CITY OF ALBUQUERQUE

Re: COLDWELL OFFICE BUILDING
10300 Cottonwood Park NW
Approval of Permanent Certificate of Occupancy (C.O.)
Engineer's Stamp dated 11/15/2005 (A-14/D16)
Certification dated 07/19/2006

COLDWELL OFFICE BUILDING
GRADING PLAN
JUL 21 2006
HYDROLOGY SECTION

**COLDWELL
OFFICE BUILDING
DRAINAGE PLAN
(FOR INFORMATION ONLY)**

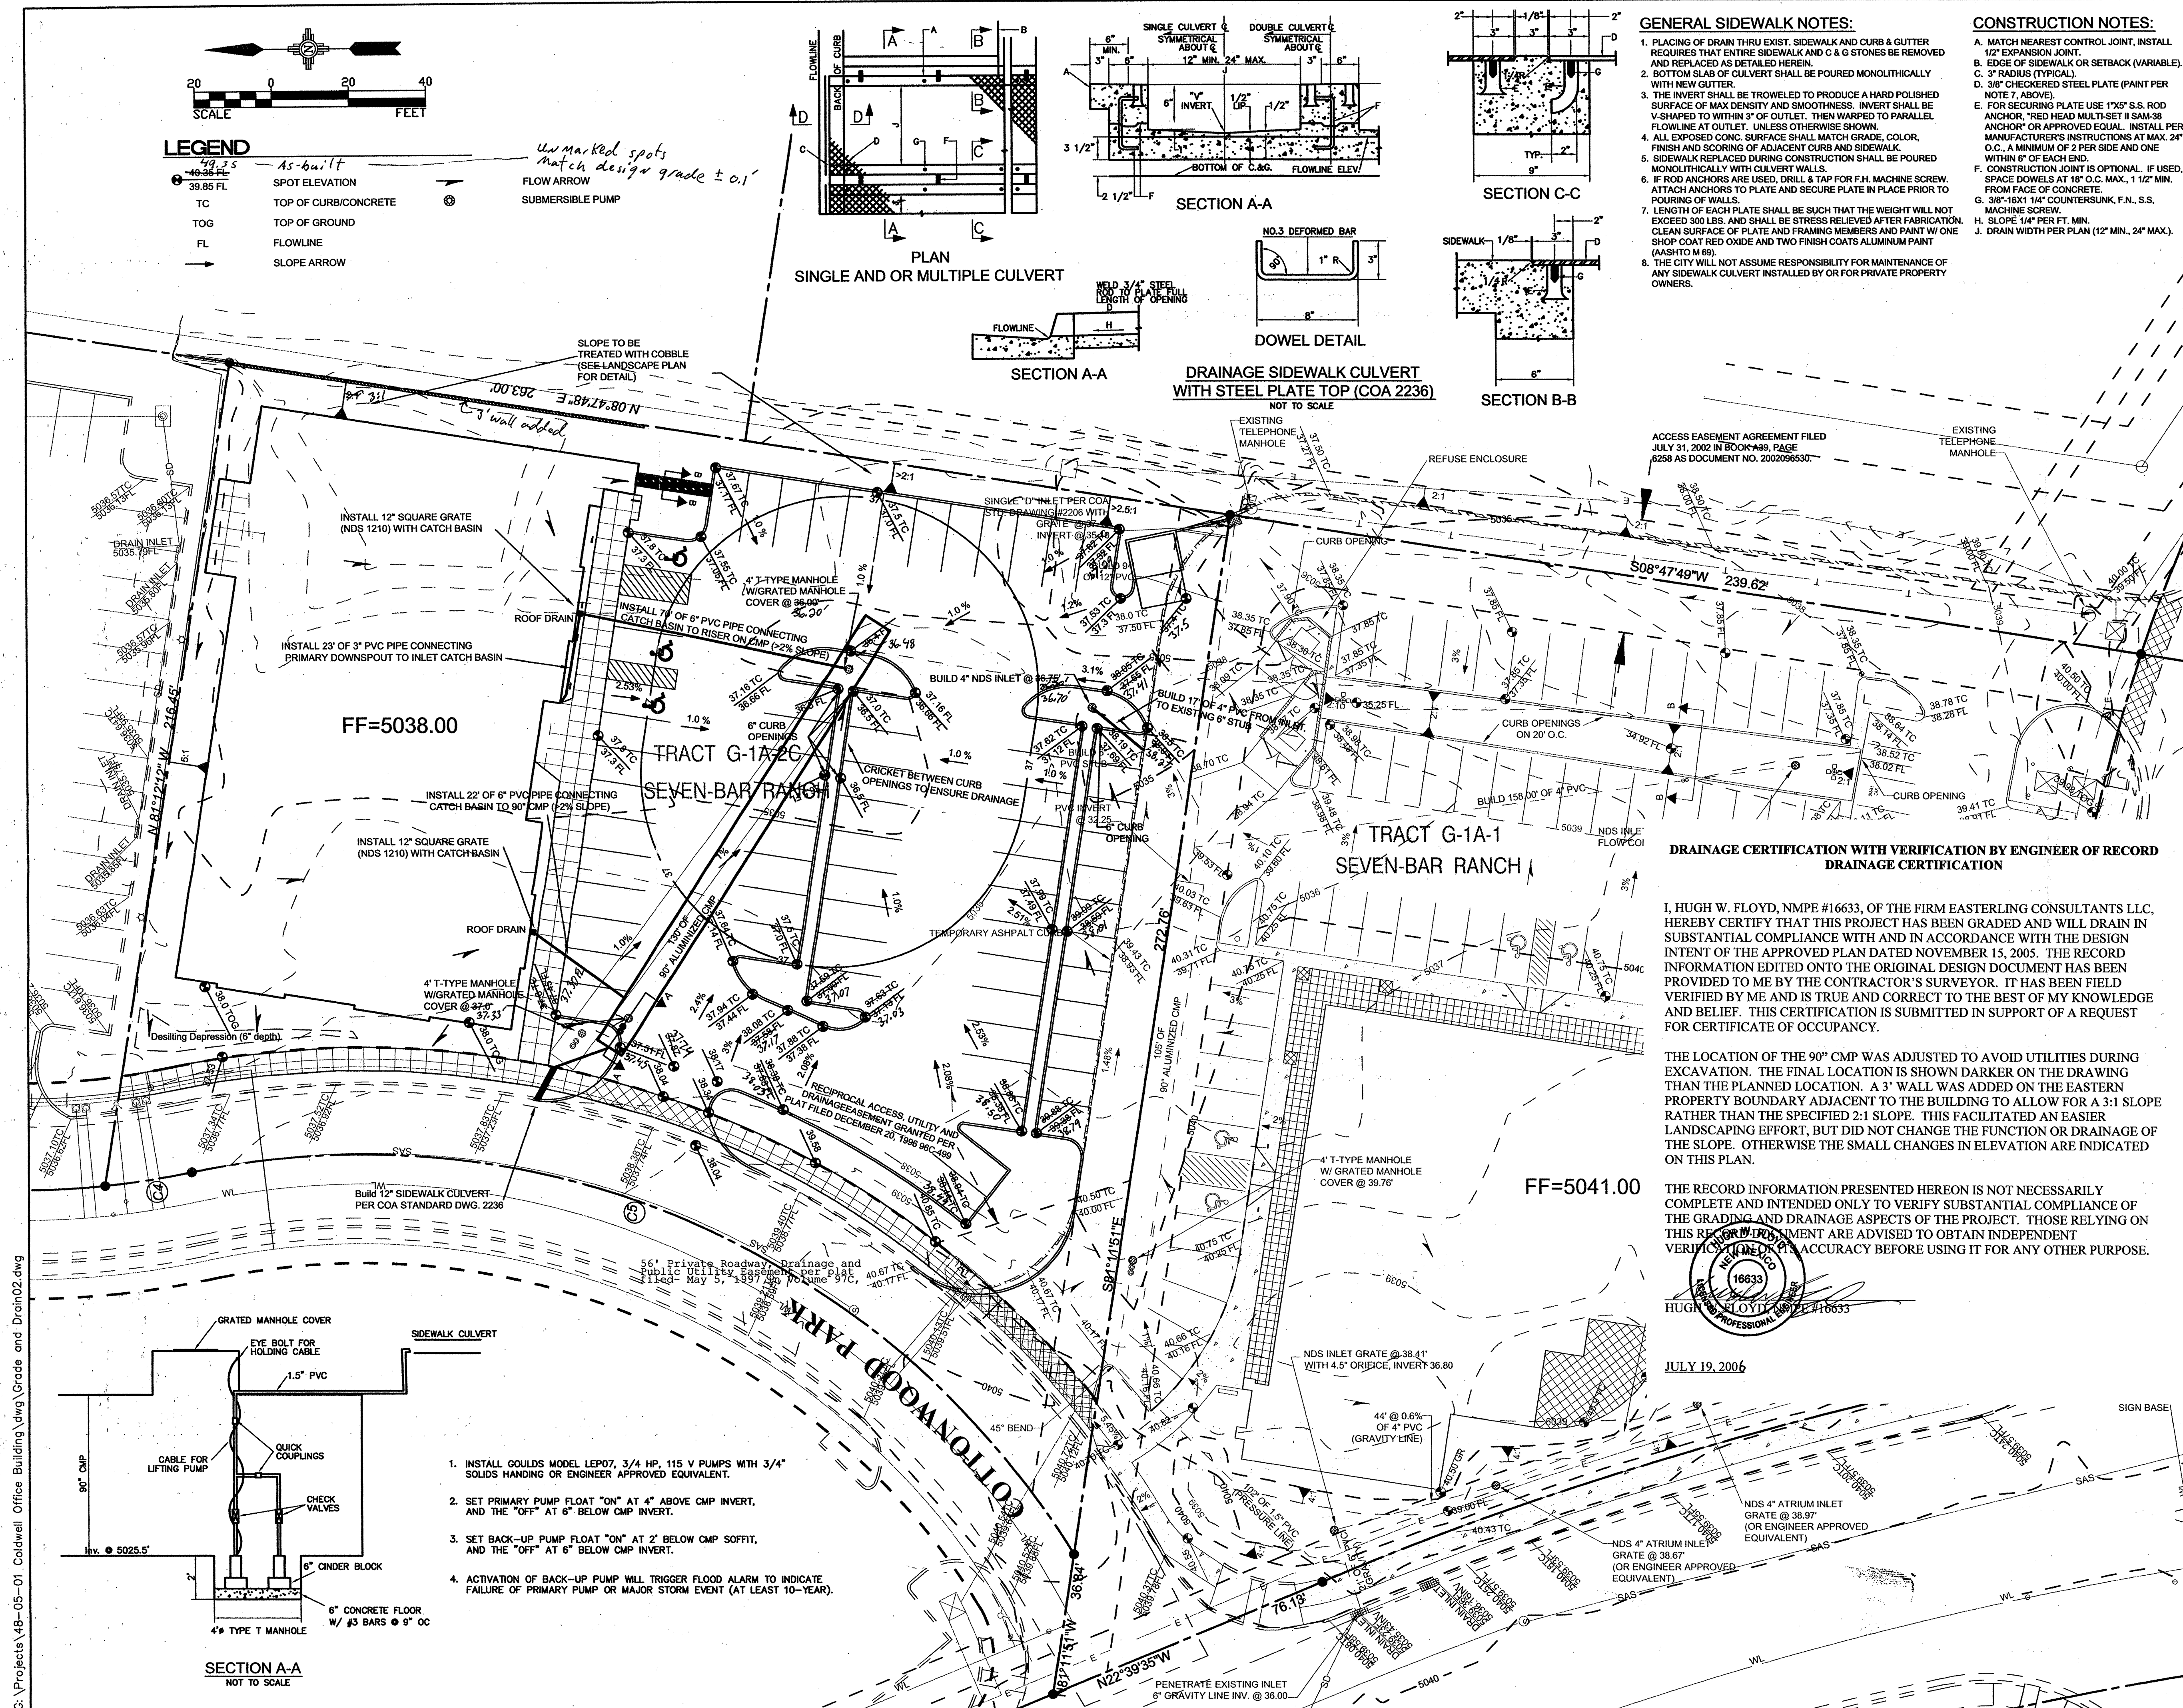
THE LOCATION OF THE 90° CMP WAS ADJUSTED TO AVOID UTILITIES DURING EXCAVATION. THE FINAL LOCATION IS SHOWN DARKER ON THE DRAWING THAN THE PLANNED LOCATION. A 3" WALL WAS ADDED ON THE EASTERN PROPERTY BOUNDARY ADJACENT TO THE BUILDING TO ALLOW FOR A 3:1 SLOPE RATHER THAN THE SPECIFIED 2:1 SLOPE. THIS FACILITATED AN EASIER LANDSCAPING EFFORT, BUT DID NOT CHANGE THE FUNCTION OR DRAINAGE OF THE SLOPE. OTHERWISE THE SMALL CHANGES IN ELEVATION ARE INDICATED ON THIS PLAN.

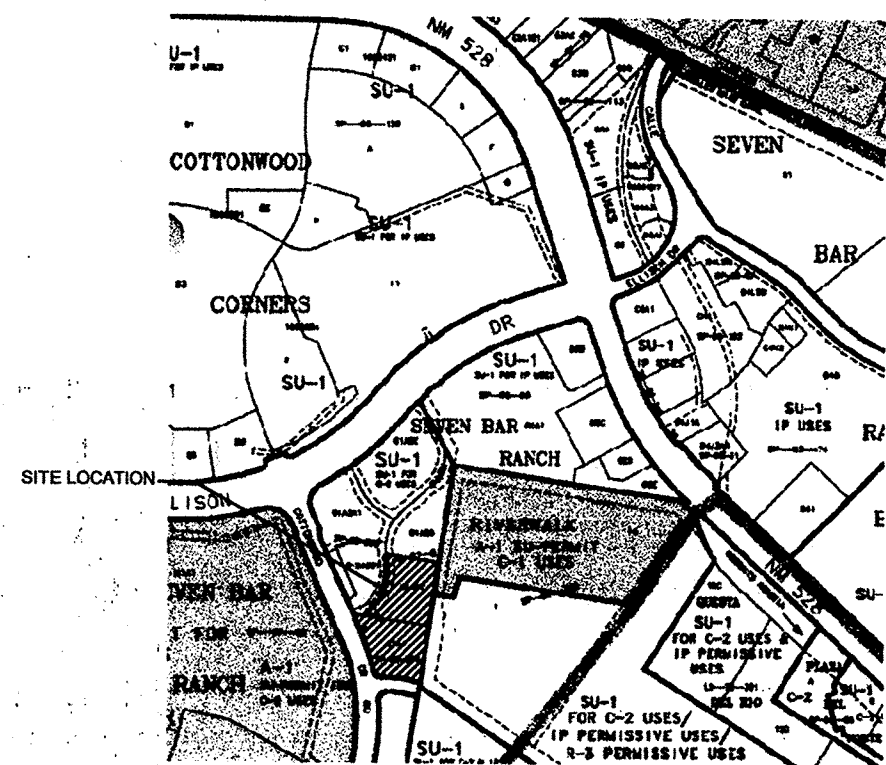
THE LOCATION OF THE 90" CMP WAS ADJUSTED TO AVOID UTILITIES DURING EXCAVATION. THE FINAL LOCATION IS SHOWN DARKER ON THE DRAWING THAN THE PLANNED LOCATION. A 3' WALL WAS ADDED ON THE EASTERN PROPERTY BOUNDARY ADJACENT TO THE BUILDING TO ALLOW FOR A 3:1 SLOPE RATHER THAN THE SPECIFIED 2:1 SLOPE. THIS FACILITATED AN EASIER LANDSCAPING EFFORT, BUT DID NOT CHANGE THE FUNCTION OR DRAINAGE OF THE SLOPE. OTHERWISE THE SMALL CHANGES IN ELEVATION ARE INDICATED ON THIS PLAN.
